ADDENDUM NO. 4

May 6, 2025

This Addendum contains changes to the requirements of the Contract Documents and Specifications. Such changes are to be incorporated into the Construction Documents and shall apply to the work with the same meaning and force as if they had been included in the original document. Wherever this Addendum modifies a portion of a paragraph of the specifications or a portion of any Drawing, the remainder of the Paragraph or Drawing shall remain in force.

**RENOVATE 2ND - 5TH FLOOR
AT KING-SHAW HALL**

04 REFLECTED CEILING PLAN - UPOLA
SCALE: 1/8" = 1'-0"

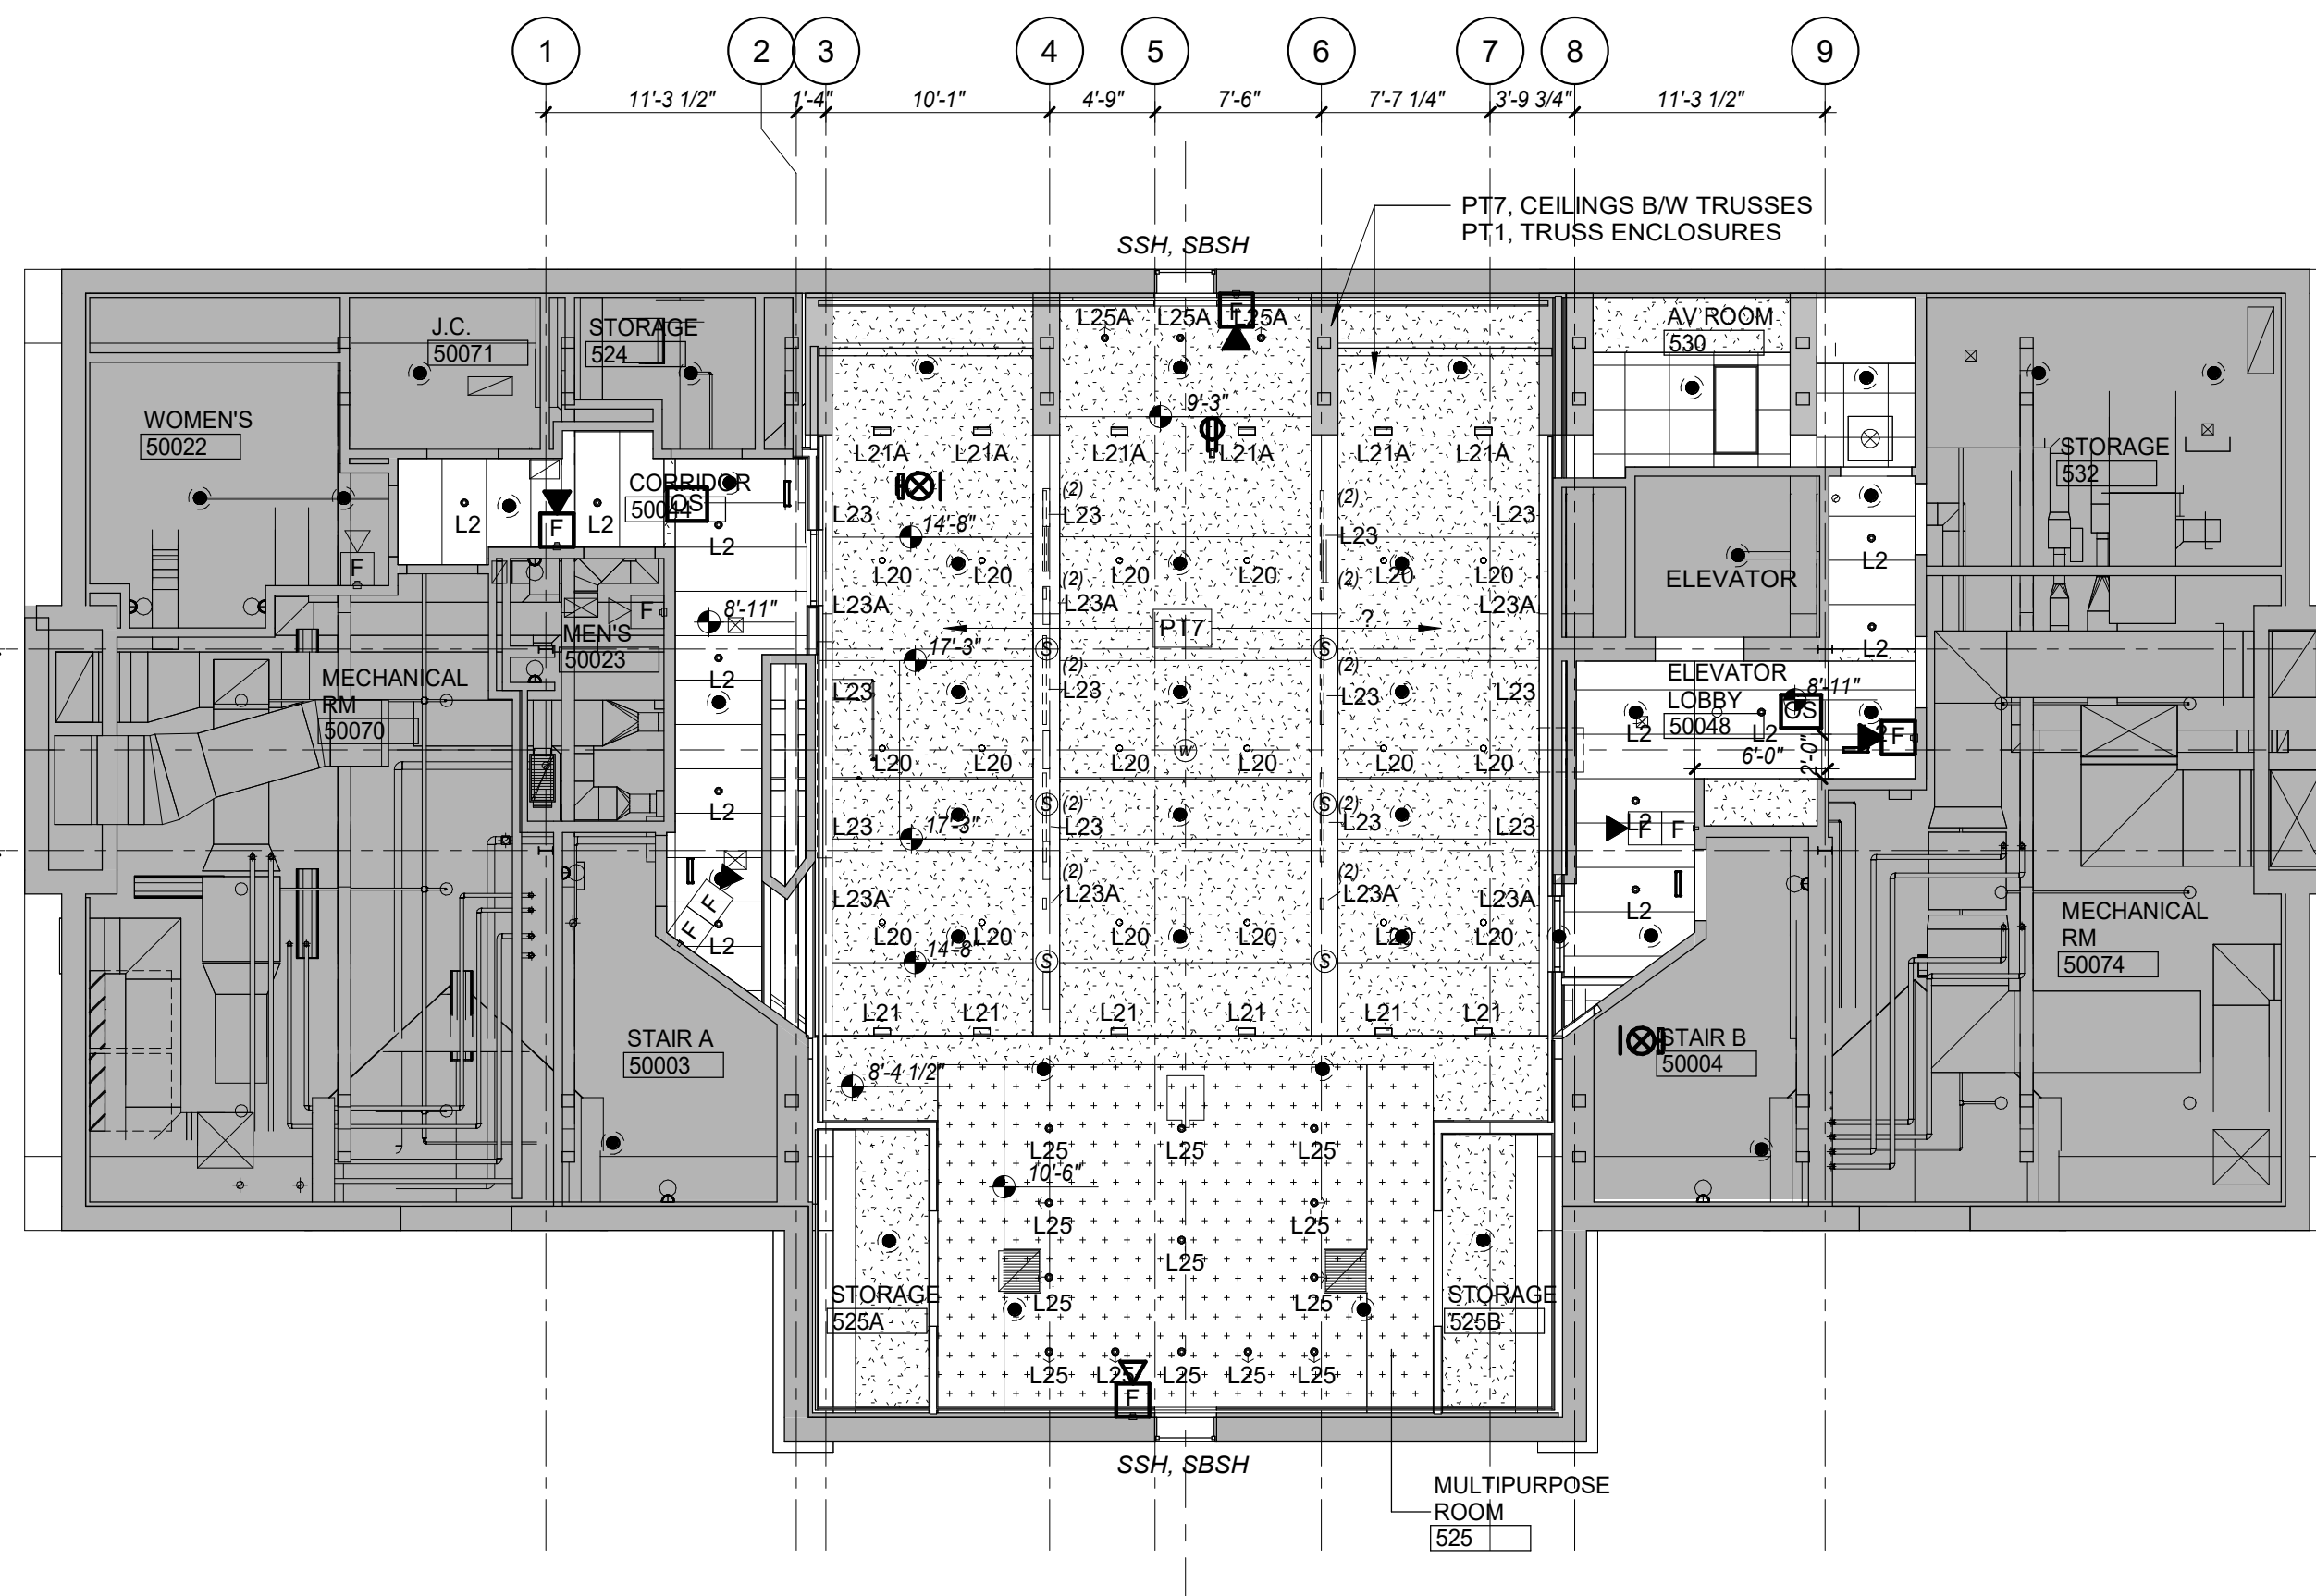
RFI/ Response Index	Page/ Dwg./Spec./Rep. Number	Section/ Paragraph/Topic	RFI	Design Team Response
26	104416	Fire Extinguisher Cabinets	Could not find any FEC shown on the drawings. There is a specification. Please clarify.	See Addendum No. 4 and revised Floor Plans locating FECs.
27	A-750	Signage	Drawing A-750 calls for vinyl signage at details 2, 3 and 5. Please update specification 101400 Signage with information regarding the vinyl signage. Also, these are called out at various interior elevations but the notes tell us to reference A-750. Sometimes it is quite clear what sign is desired but other times it is not. Can the interior elevation notes be updated to add which specific detail on A-750? This will help our signage vendors to provide the most accurate pricing possible.	Signage scope to be confirmed with Owner. See notes at detail 05 on Drawing A-750 for current scope information.
28	A-740	OFCI Items	Please reference A-740. The finish schedule calls for the Composite Paneling that is specified in section 068300 as OFCI. The specification does not indicate that this product is OFCI. Please clarify who is to be providing this product. Same question for items UF1 & UF2. All of the fabric items within specification 098413 Acoustic Panel Fabric are listed as OFCI as well. Please confirm who is to be providing these products.	Composite Paneling, UF1, UF2, and acoustic panel fabrics are Owner-Furnished, Contractor-Installed.

FS-100R

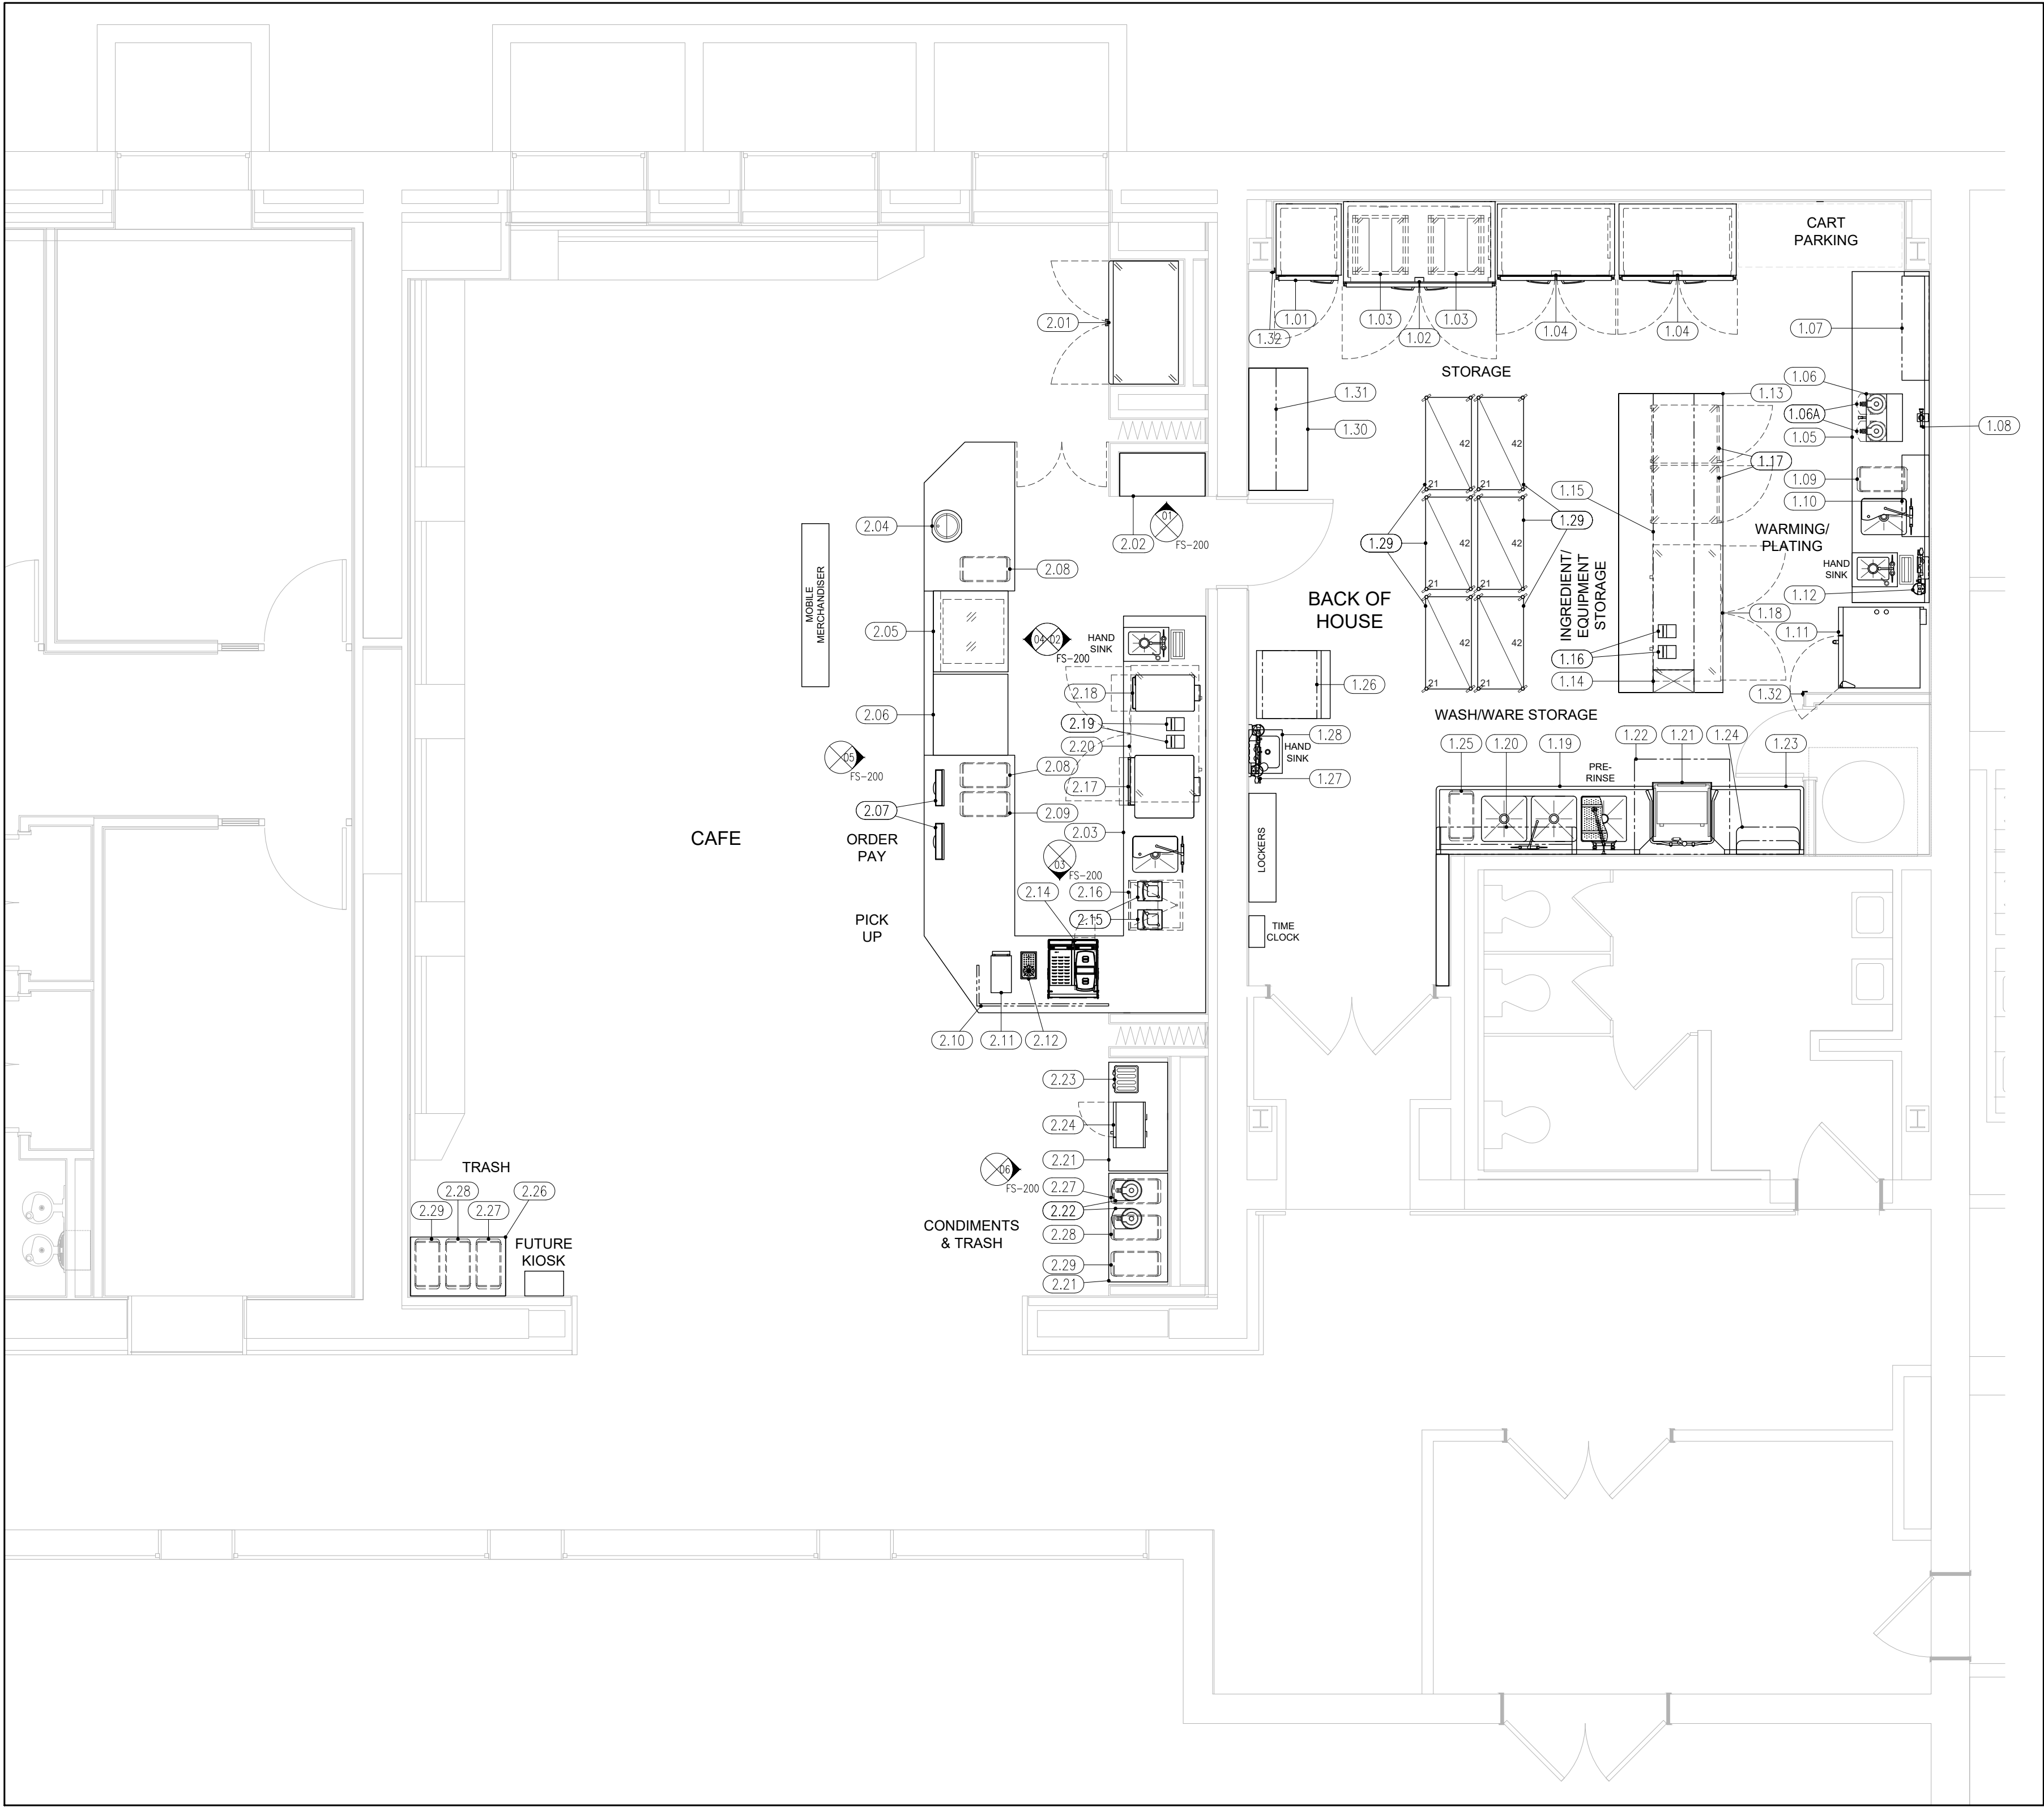
24	FS-100	Equipment Schedule	2FL Foodservice Equipment Plan FS-100, has the equipment schedule with an Equipment Remarks column. This remarks column identifies items to be supplied by the GC.	See Addendum No. 4, Item 8 for revised drawing.
25	Appendix E	Owner-Furnished Items	Appendix E - Identifies Owner Furnished Interior finishes materials including certain upholstery fabrics, textured wall paneling, ceramic tile & carpet. Also identifies certain light fixtures the owner will supply.	Items are Owner-Furnished, Contractor-Installed.

REPLACE with revised Drawing FS-100R, attached.
